## Eight Discipline Report (8D Report)

To:	8D report No.:
From: : <b>Chicony Power Technology</b>	RMA claim No.: <b>N/A</b>
CC :	Chicony Power P/N: <b>A180AP01Q-FW01</b>
	Customer P/N: <b>PK37A019500</b>
Submit date: <b>2023/6/28</b>	Product description: <b>180W PD</b>
Receive date: <b>2023/6/16</b>	Defect D/C or Lot No.:
<b>Subject : 客戶反饋搭配系統測試 RE, 在 61MHz 頻段 margin 不足 (EMI RE, 點膠/Glue)</b>	
<b>D1.) 問題解決成員: Use Team Approach</b>	
主持者 (Team Leader) : <b>Cf Liu</b> 內部成員 (Internal Team Members): <div style="text-align: center; margin-top: 10px;"> <b>CQS: Jack Wang</b>  <b>QE: Kitty Zhang</b>  <b>MFG: Xiaohui Du</b>  <b>PE: Yong Liu</b>  <b>Sales: Gordon Wang</b>  <b>RD: Chris Wu</b> </div> 外部成員 (External Team Member):	
<b>D2.) 問題說明: Problem Description:</b>	
(Note: Use <b>who, what, when, where, why, how, how many</b> to specify the Customer's problem.)	
<b>2023/6/16 仁寶告知目前 10M 場地 30MHz~1GHz 的輻射測試在低頻 30MHz~230MHz 之間會看到 power noise, 拔掉電源會降下去。</b> <b>其中在 61MHz 的 peak 較高, Qp 抓起來會沒達到客戶 spec (Qp -4dB 以下), 如下圖所示。傳導測項則是 pass。</b> <a href="https://fr.mw/FRANCNCH713174002G" style="color: blue; text-decoration: none;">https://fr.mw/FRANCNCH713174002G</a>

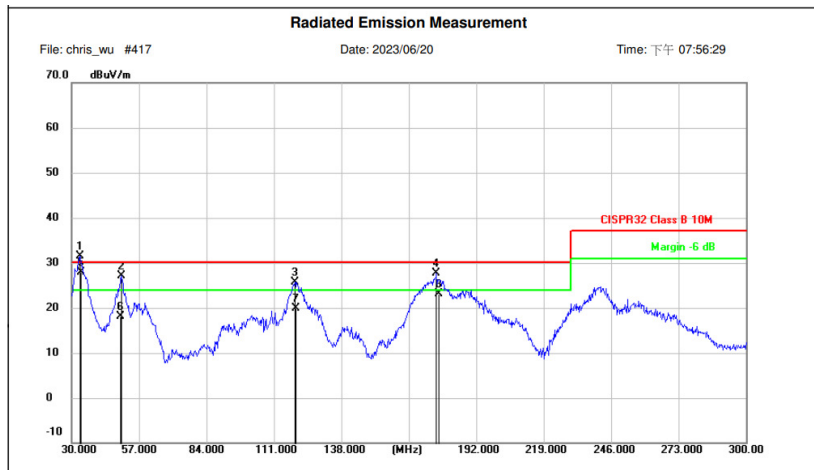
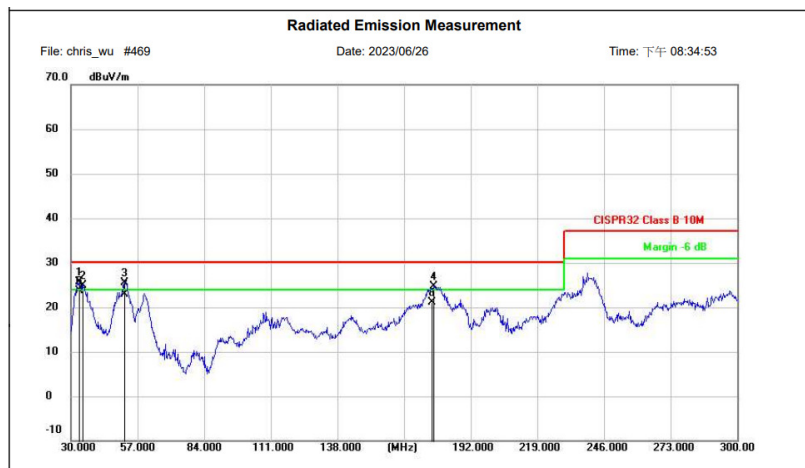
1. 透過追蹤我們SFCS中的SN (FRANCNCH713174002G)，該樣機通過了生產線中的所有測試站。
2. 在群電內部實驗室測試此樣機的EMI RE，發現在50MHz頻段確實比較差。
3. 打開外殼，觀察元件面跟錫面，元件面及錫面看起來無異常，且錫接面錫接良好

但有發現錫面點膠未按照生產注意事項點膠，以至於紅圈處(AHB circuit與PFC circuit；一次側與二次側)的膠有連起來，導致EMI\_RE變差。

4. 將紅圈處的膠挖起來再進行驗證，EMI\_RE 50MHz頻段約好2~3dB PK

Before:

After:

1. 透過上述分析，我們得出結論主要是膠與零件相連在一起便增加了零件間的耦合強度又因為膠連到的地方為紅框處這 2 個地方，1).AHB circuit 與 PFC circuit ； 2).一次側與二次側， 這 2 個地方的切換頻率相差約 1 倍使得這個切換開關雜訊被這個增大的耦合強度耦合到外部造成 EMI 變差。

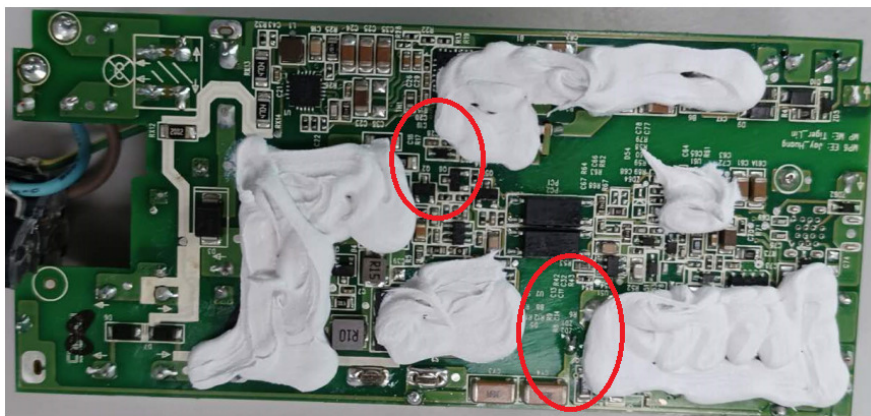
1. 把紅圈處的膠挖掉後再用Dummy load驗證EMI\_RE在頻段約50MHz可看到有明顯降低
2. 要求工廠務必按照生產注意事項裡的點膠方式作業
